**AGENDA FOR REGULAR MEETING
VILLAGE OF TINLEY PARK
PLAN COMMISSION
April 16, 2015 – 7:30 P.M.
Council Chambers
Village Hall – 16250 S. Oak Park Avenue**

E&B LIQUORS (former Family Video Store) – 16948 S. OAK PARK AVENUE – SITE PLAN APPROVAL AND SPECIAL USE PERMITS FOR A PACKAGE LIQUOR STORE AND A MIXED-USE BUILDING (Commissioners Ficaro and Mahoney)

BRIXMOR OUTLOT – 15917 S. HARLEM AVENUE – SITE PLAN APPROVAL AND A SPECIAL USE FOR A SUBSTANTIAL DEVIATION TO THE TINLEY PARK PLAZA PLANNED UNIT DEVELOPMENT (New Item)

PLAN COMMISSION STAFF REPORT

CIRCULATION

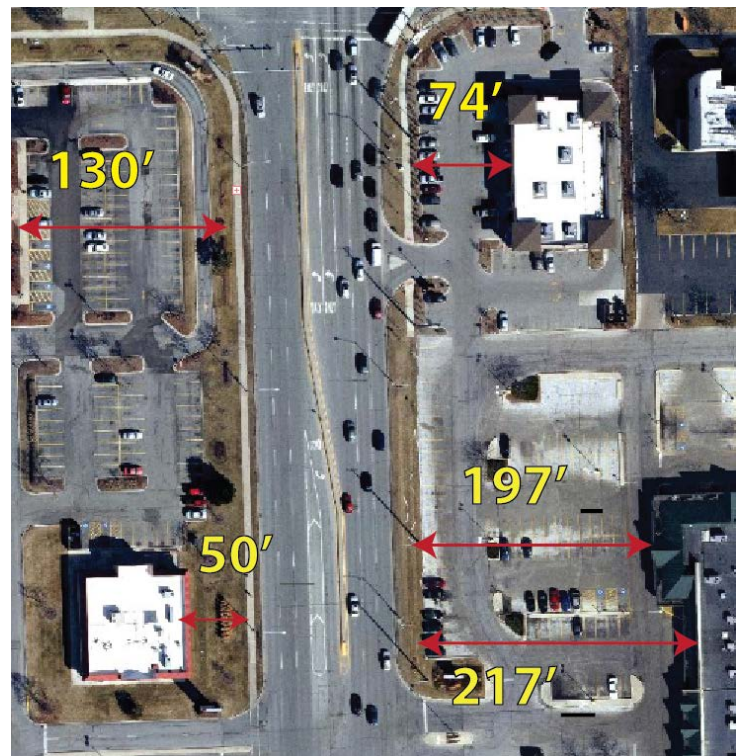
Per Staff's request, the Applicant has aligned the access in front of their building with the south access from the Tinley Square development. This will facilitate cross-access between the lots. Staff has reviewed the file for the property to the north (Tinley Square) and found reference to a cross-access easement, however the easement has not been platted with either property. Staff has encouraged the property owner to plat a cross access easement with the redevelopment of the property.

Open Item #1: No cross-access easement exists between subject property and Tinley Square.

Area 1

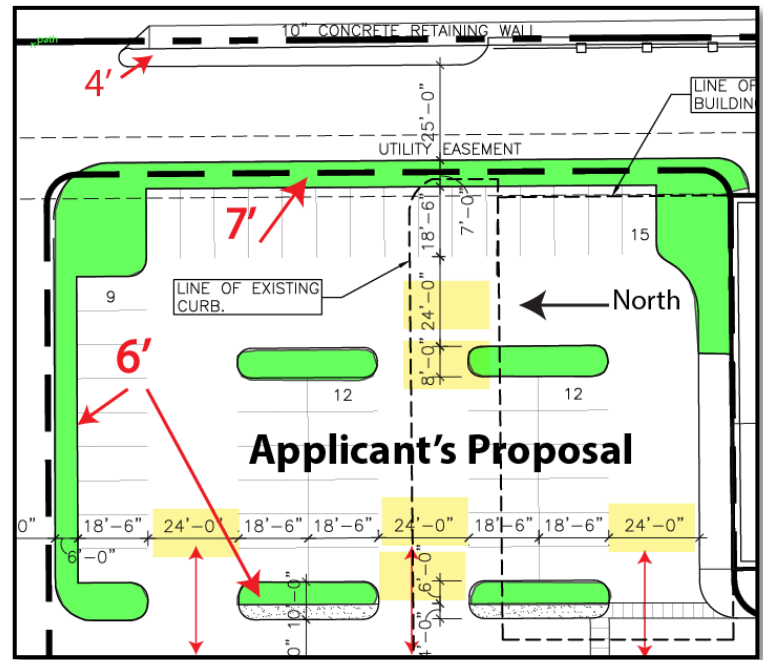
The Applicant's proposed parking field in Area 1 does not meet the minimum aisle width requirement of 26' (proposed 24'), nor does it provide the required 10' wide landscape island requirement (proposed 6' and 8'). The bufferyard on the north edge of the parking lot is 6', however the east edge of the parking lot measures 7' and the greenspace on the west side measures 6'. Bufferyards between retail uses is required to be a minimum of 5', however parking lots must also be adequately screened from public view and must accommodate a three (3) foot bumper overhang from the face of the curb. The north bufferyard may meet minimum bufferyard width requirements, however after accommodating a car bumper overhang, it is left with only 3' of planting area.

The east bufferyard for Area 1 is actually further east of the parking area, at the property line on the east side of the delivery aisle "B". It currently measures 4'; there is a 6' fence further south. The parking field has been shifted east in the Applicant's proposal and narrows the delivery aisle from 30' to 25' to provide additional greenspace along the eastern edge of the parking field; however with a 7' wide greenspace as proposed, only 4' is available for planting with the accommodation of a 3' car bumper.

The Applicant's proposal provides three (3) points of access to the main north-south drive aisle ("A") adding two (2) additional points of conflict from the existing configuration. Parking is provided for 48 cars; 26 spaces currently exist. A parking analysis is provided in a later section. A total of eight (8) variations from code are required with this proposal, not including inadequate landscape screening.

Staff's recommendation for Area 1 provides for diagonal parking. The aisles meet ordinance requirements, and landscape islands meet minimum width requirements; bufferyards and parking lot screening also meet Ordinance requirements. No variations from code are required with this proposal.

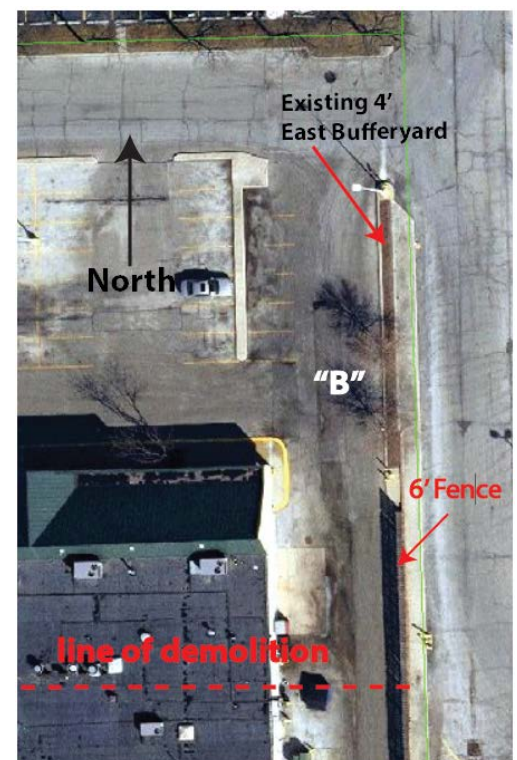
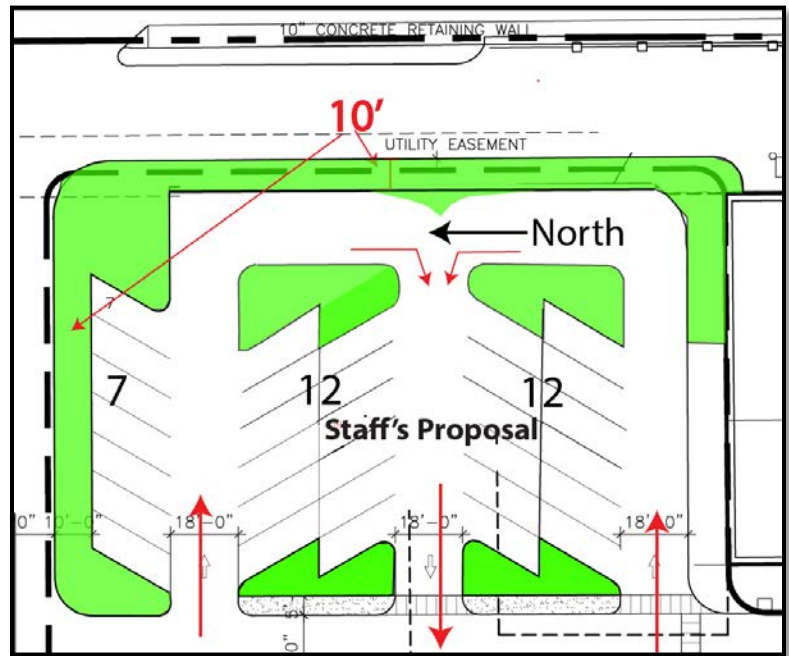
In Staff's Site Plan proposal the north bufferyard is increased to 10', which provides for 7' of landscaped area and a 3' bumper overhang. The proposal also provides for increased green space at the east end of the parking lot measuring 10' in width. The Village engineer indicated his preference for Staff's Site plan

proposal stating: "...layout with diagonal parking to the east of the site would be preferred due to the added pervious surface that would be created. This site was permitted long ago with TP-40 rainfall and thus is deficient in the volume requirements for the detention. Added pervious surfaces are very important to reduce site runoff. Landscaped areas that could also double as rainwater gardens would be desirable. Pervious surfaces should be maximized."

In addition, the Applicant's proposal limits points of egress to one (1), thus lessening possible points of conflict with the main north-south drive aisle. There are thirty-one (31) parking spaces provided; currently there are twenty-six (26) provided. Parking ratios are discussed in a later section.

Open Item #2: East parking area does not meet aisle width requirements.

Area 2

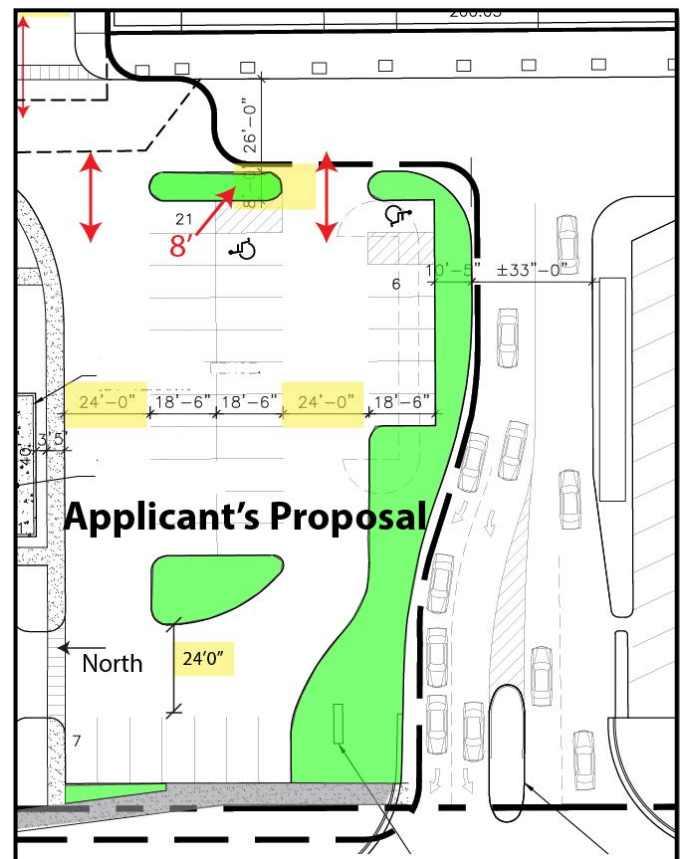
Area 2 comprises the parking field to the south of the proposed multi-tenant structure and includes the entry boulevard from Harlem Avenue. The Applicant proposes to move the south edge of the parking field to the south thus narrowing the entryway boulevard to one lane in each direction at the east end of the entryway. This reduces the width of the entry boulevard from 47' to 33'. There will remain four (4) lanes at its intersection with Harlem Avenue. The parking field as proposed does not meet code with respect to the required 26' aisle width (24' proposed) and required 10' parking islands (8' proposed).

The six (6') foot public sidewalk required along the Harlem Street frontage will need to be relocated out of the public ROW at the south end of the property due to the topography and deep drainage swale. The Applicant will need to record a public access easement for this encroachment onto their property. The sidewalk as proposed borders the western edge of the parking lot. The public walk will not only be encumbered by car bumper overhangs but the bufferyard (minimum 10') and landscape screening is eliminated in this area. There are thirty-four (34) parking spaces proposed for Area 2. (Parking ratios to be discussed later in the report.)

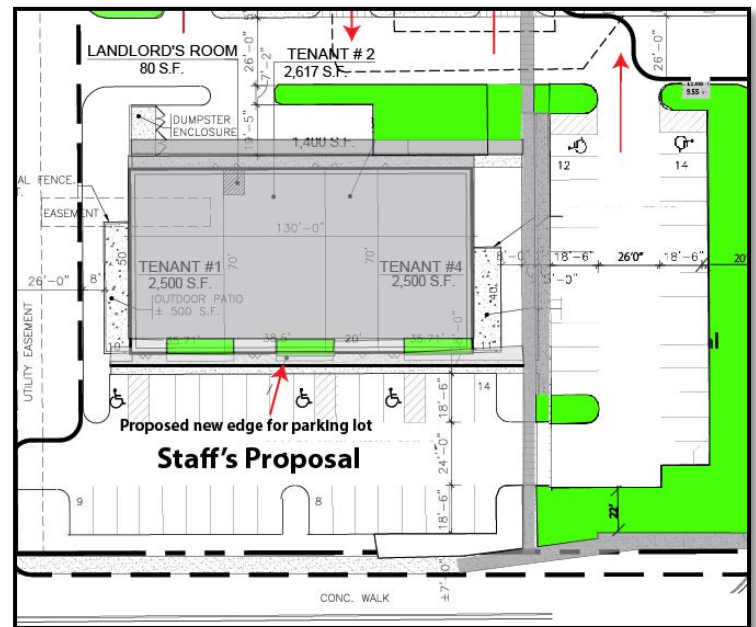
The sidewalk proposed along the front of the proposed structure is identified at five feet (5'). The bumper overhang of cars parked along this sidewalk will reduce its usable width to less than three feet (3'), thus compromising ADA accessibility. Recent development approvals in the Village have provided 6.5-7' sidewalks in these situations.

The Applicant has stated that the width of the dumpster is the limiting dimension when considering moving the building to the east and it is currently proposed at the minimal width of the desired dumpster. Staff has recommended the Applicant investigate alternate means of accessing the dumpsters or smaller dumpsters. If the building were relocated to the east it would not only provide for the required aisle width but it would also increase the amount of foundation planting required in front of all commercial buildings.

Open Item #9: Sidewalk in front of proposed building does not provide adequate accessibility.

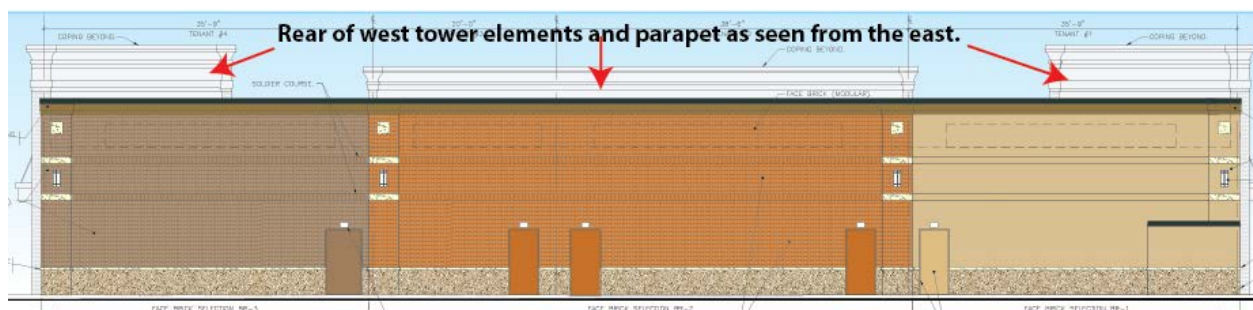
The proposed architecture presents "column" corner elements on both the north and south ends of the building, on the west façade. While these are attractive elements of the "front" façade they have not been designed as full parapets. The proposed structure has a large view shed and visibility from the east, and the lack of a full parapet results in an unfinished and artificial look to the building. It would be apparent when viewed from the east, as well as from the south, that the tower element is not a "true" tower, but merely a design element mimicking a real tower. Recent projects such as DaVita Dialysis, Wendy's and some of the outlot structures in the Brookside Marketplace development have provided full parapet designs per Plan Commission recommendation.

Open Item #13: *The tower elements on the west façade do not have four fully architecturally developed sides.*

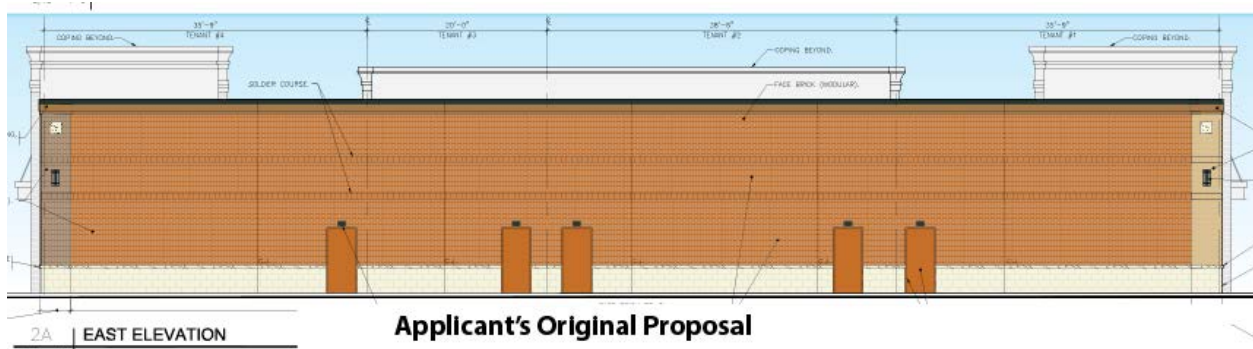
During development review meetings with the Applicant, Staff recommended some modifications to the west façade that would reduce the use of EFIS in the tower elements. The Commission has expressed concern regarding the use of this material in the past and therefore Staff has advised the Applicant to minimize its use. Staff proposed the following changes which included raising the brick of the column elements to the roof line and added an arch element at the top of the EFIS area. The arch could add additional shadow lines similar to the proposed cornice.

Open Item #15: The EFIS surface area encompasses a large area on four corners of the building.

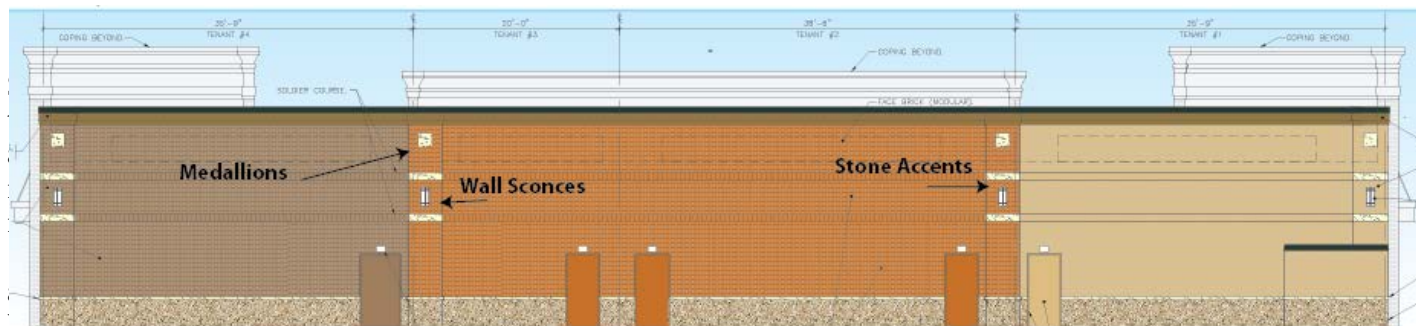
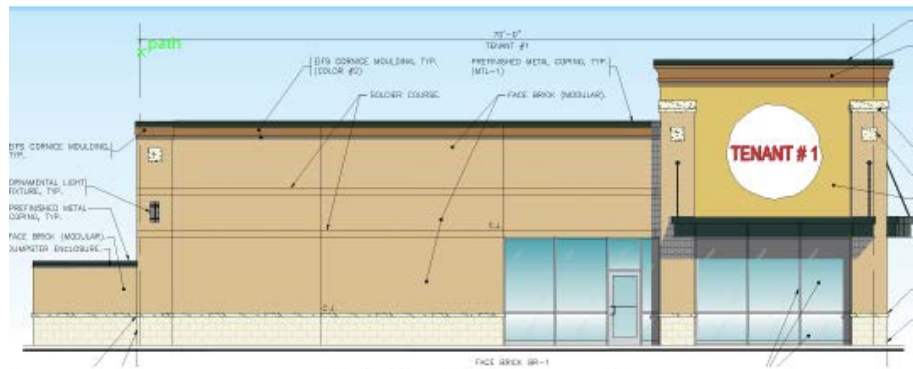
The Applicant has provided some additional architectural enhancements to the rear façade from what was originally proposed (which was lacking in architectural interest compared to the other facades). As stated above, all four sides of this building must present attractive architecture indicative of quality commercial architecture. The Applicant has incorporated several of Staff's recommendations including a change in brick color that echoes the brick colors of the individual tenant spaces as seen on the west façade. A 4" reveal reflects a column element with stone accents and medallions have been added. These revisions along with the additional green space as recommended by Staff will help to mitigate the appearance of a "rear" façade.

Staff also made some recommendations for the north and south facades to provide additional architectural interest.
